Interactive comment on “Calibration of the SBUV version 8.6 ozone data product” by M. T. DeLand et al.

Received and published: 16 October 2012

Fig. 1. Profile ozone differences between Aura MLS and SBUV V8 data (top) and SBUV V8.6 data (bottom).

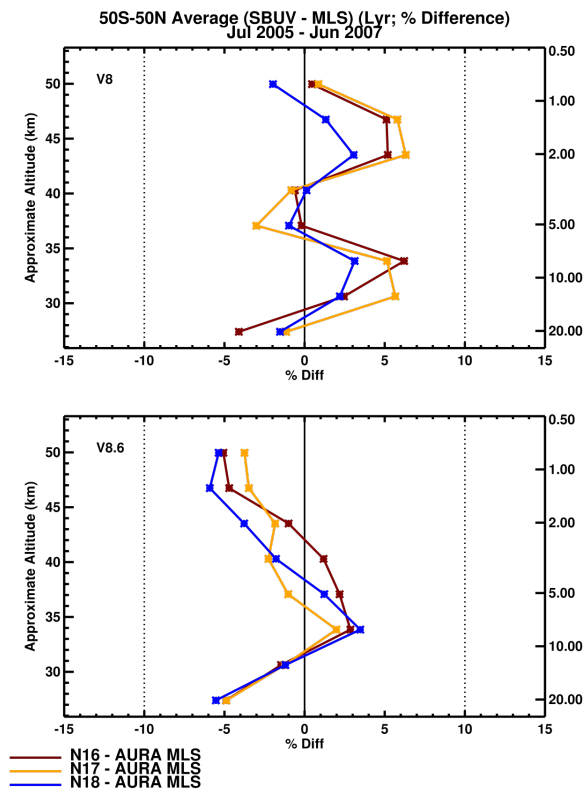
- The main goal of all the calibration procedures applied to the SBUV spectra is to improve the consistency between the ozone profiles retrieved from the different sensors. The procedures themselves are clearly described. But the paper would greatly benefit from an illustration of the impact of these calibrations on the retrieved ozone profiles themselves, where possible. Is it possible to show how improved is the consistency

between the ozone profile data sets from the different instruments as a consequence of some of the calibration procedures?

» While other forthcoming papers from our group address the behavior of the SBUV V8.6 ozone products in extensive detail, we agree that an illustration of the improved data quality in this paper is also useful. We have added Figure 12 in the revised manuscript to compare the agreement between Aura MLS profile ozone data and data from overlapping SBUV/2 instruments (NOAA-16, NOAA-17, NOAA-18), using both our previous Version 8 (V8) product and the new V8.6 product.

Revised Text (p. 5168, after line 15). The improvement in ozone profile data quality produced by the calibration changes discussed in this section is noticeable when examining data from the most recent SBUV instruments on NOAA-16, NOAA-17, and NOAA-18. Figure 12 shows zonal average profile ozone comparisons with Aura MLS Version 3.3 ozone data, using both the previous SBUV V8 data product (top panel) and the current V8.6 data product (bottom panel). The significant decrease in oscillating vertical structure, or “ringing”, for the V8.6 comparisons comes from the channel adjustment procedure used for NOAA-17. The improved agreement between these three SBUV instruments in the V8.6 product comes from the use of the “no local time difference” intercalibration technique.

Caption for Figure 12. Profile ozone differences [in percent] between Aura MLS V3.3 data and SBUV/2 instruments on NOAA-16, NOAA-17, and NOAA-18, using zonal averages between 50°N–50°S for the period July 2005 – June 2007. Comparisons to the SBUV V8 data product are shown in the top panel, and comparisons to the SBUV V8.6 product discussed in this paper are shown in the bottom panel.
